**CAIRNGORMS NATIONAL PARK AUTHORITY**

**Title: REPORT ON CALLED-IN PLANNING APPLICATION**

**DEVELOPMENT PROPOSED: CONSTRUCTION OF ACCESS ROAD AND DEVELOPMENT OF 18 HOUSE PLOTS AT WOODLAND NORTH OF WEST TERRACE, KINGUSSIE (OUTLINE PP)**

**REFERENCE: 06/054/CP**

Fig 6. Proposed Site Plan (indicative)

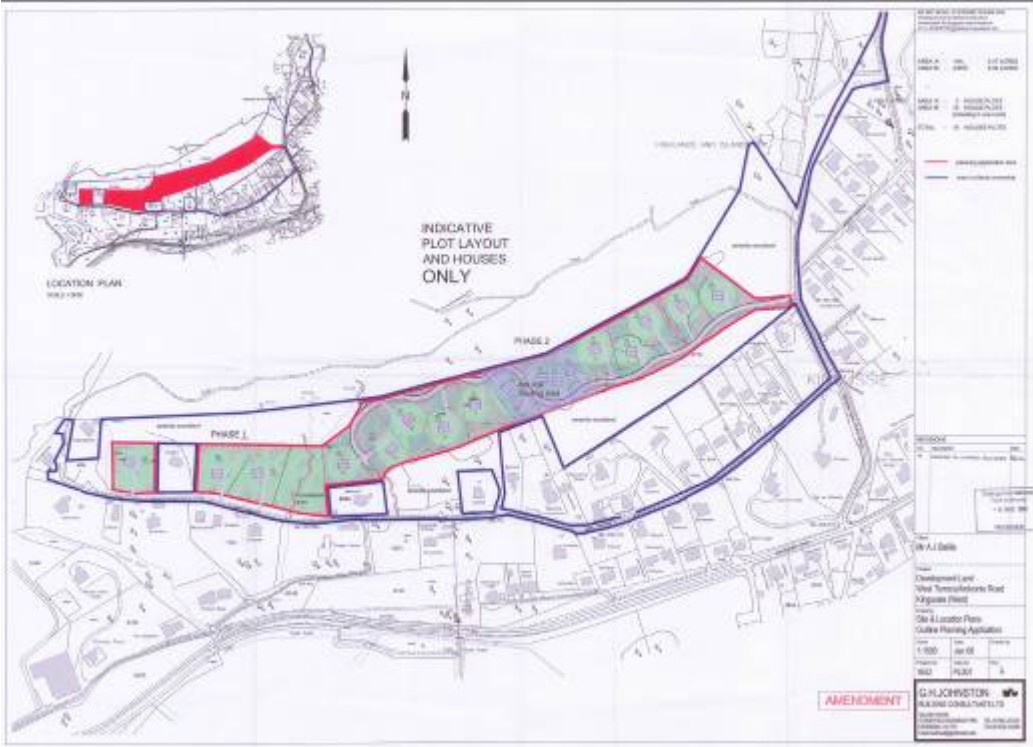
3. This application is in outline form and seeks permission for the construction of 18 house plots with an access road to serve them. The site would be accessed from Ardvonie Road immediately above a property known as Fasnakyle.
4. The access road would then traverse along the southern boundary of the site before rising through an area of 5 plots described as low cost housing. The road would then gain height to the upper level of the site to 5 remaining plots. A total of 15 house plots would be accessed in this way with the remaining 3 being at the western end, effectively infill plots accessed directly from West Terrace itself (see fig 6). Areas remaining free from development on the plan are indicated as amenity woodland.

19. **Scottish Natural Heritage** has no objection to the proposal. The site lies within the Cairngorms National Park. There are no other designated sites in the area. According to the Inventory of Ancient and Long Established Woodlands, the area to the north of the proposed development is long established woodland of plantation origin. The woodland within the development area is not classified in this inventory.

43. The steep slope of the site means that any development requiring level ground, housing and roads, will require considerable cut and fill to achieve it. This will take up significant areas apart from those required to be built on themselves. The positioning of the access road close to the boundary is of concern as the line of the road would require more land take than just for the line of the road. The plots taken together with the implications of the road across such a steep site would mean that little of the woodland would remain after construction.

Fig. 7 Local Plan allocation 1.4 (d) & (c)

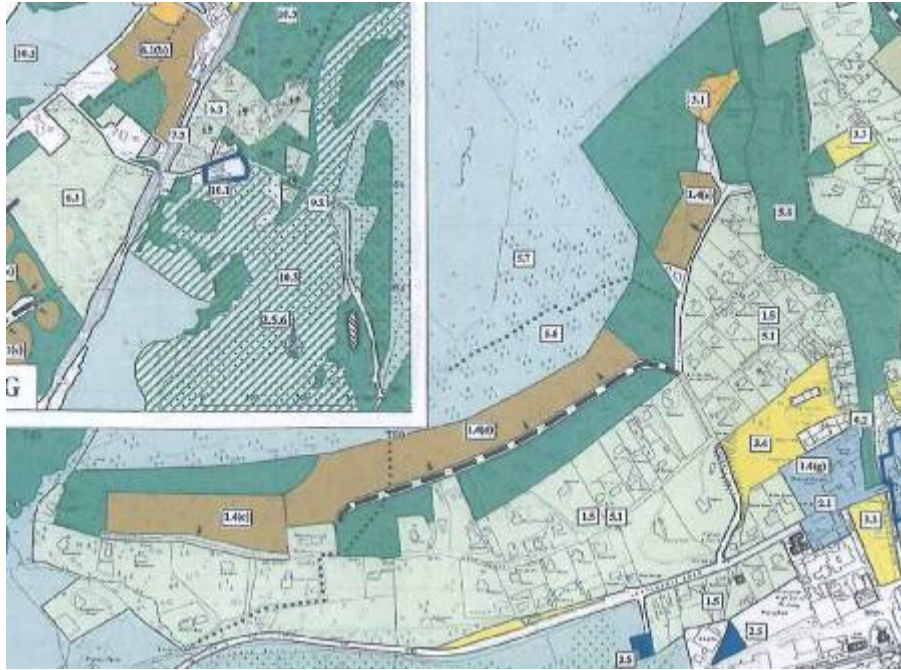
16. Under 7.1.4 Housing Allocations (small sites) this application site is identified as being covered by Area (c) at the western end of west terrace for 4 houses being directly accessed from West Terrace and (d) Ardvonie Road at 6.5 ha with a capacity for 12-15 houses (see fig 7). Requirements of allocation (d) include upgrading of Tait's Brae drainage measures and retention of trees and safeguarding of footpaths. A site to the north of this application site (e) St Vincent's at 2.9 ha is identified for 3-4 houses with requirements as for the (d) area allocation (see fig 7 of this report)

50. The application has been put forward in a manner that generally reflects the allocation in the Kingussie section of the Badenoch and Strathspey Local Plan (see figs 6 & 7). Because of this, there is an assumption that the scheme should receive permission in principle unless there are significant material considerations that would indicate otherwise. In this case there are considered to be a number of material considerations of significant weight to call into question an approval of the scheme.
